Access Compliance Report

Public Rights-of-Way

(Curb Ramps)

Intersection ID: 10014519	Main Street: UNIVERSITY_POINTE_BV	Cross Street: N/A	Location: N
ADA ID: B94C2E954102	Ramp Type: PerpDiag	Initial Pass/Fail: Pass	Overall Compliance: No
Severity Score: 0.25			
Codes/Mitigation Info/Possible Solution		Field Measurements/Component Compliance

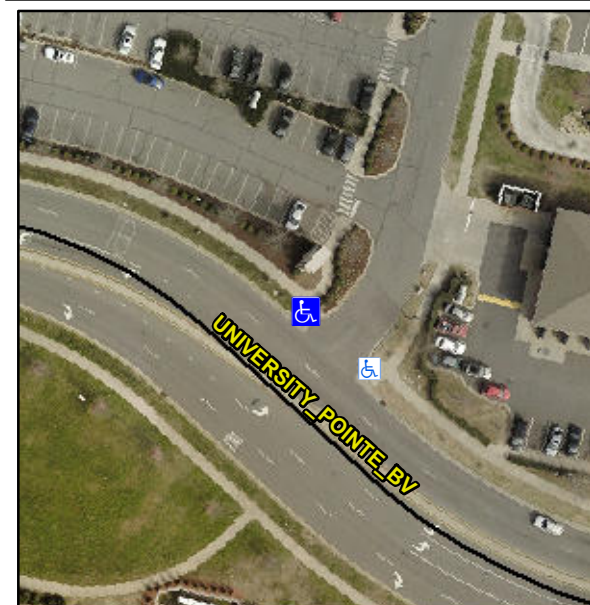
Compliance	Description	Data	Compliance	Description	Data
N/A	Ramp Length (in)	104.0	Yes	Ramp Slope (%)	7.7
Yes	Ramp Width (in)	48.0	No	Ramp XSlope (%)	4.7
N/A	Flare Type LT	Sloped	N/A	Flare Type RT	N/A
N/A	Flare Slope LT (%)	3.6	N/A	Flare Slope RT (%)	9.5
N/A	Flare Traversable LT?	No	N/A	Flare Traversable RT?	No
Yes	Landing Length (in)	60.0	Yes	DWS Provided?	Yes
Yes	Landing Width (in)	48.0	Yes	DWS Contrast?	Yes
No	Landing Slope (%)	2.6	Yes	DWS Length (in)	24.0
No	Landing X Slope (%)	5.0	Yes	DWS Full Width?	Yes
N/A	Landing Curb? (Y/N)	No	Yes	DWS Offset (in)	1.75
N/A	Shared Landing?	No			
Yes	Gutter Ponding?	No	Yes	Gutter Slope (%)	1.6
Yes	Gutter Lip Ht (in)	0.0	No	Gutter X Slope (%)	2.3
N/A	Painted X Walk1?	No	N/A	Painted X Walk2?	No
	X Walk 1 Direction	To SW		X Walk 2 Direction	To SE
N/A	X Walk 1 Width (in)	N/A	N/A	X Walk 2 Width (in)	N/A
	X Walk 1 Slope (%)	1.4		X Walk 2 Slope (%)	2.7
	X Walk 1 X Slope (%)	2.1		X Walk 2 X Slope (%)	0.6

N/A	Ramp inside XWalk1?	N/A	N/A	Ramp inside XWalk2?	N/A
	Road Slope (%)	3.1	N/A	Clear Space?	Yes
	Road X Slope (%)	0.6	N/A	Clear Space to XWalk (in)	N/A
Yes	Any Obstructions?	No	Yes	Storm Grate/Utility Hazard?	No
	Obstruction Type			Storm Grate/Utility Type	
		N/A			N/A
			Yes	Surface Condition? (G/P)	Good

Remove & Replace Curb Ramp With Two New Directional Ramps or Equivalent. Remove & Replace Gutter.
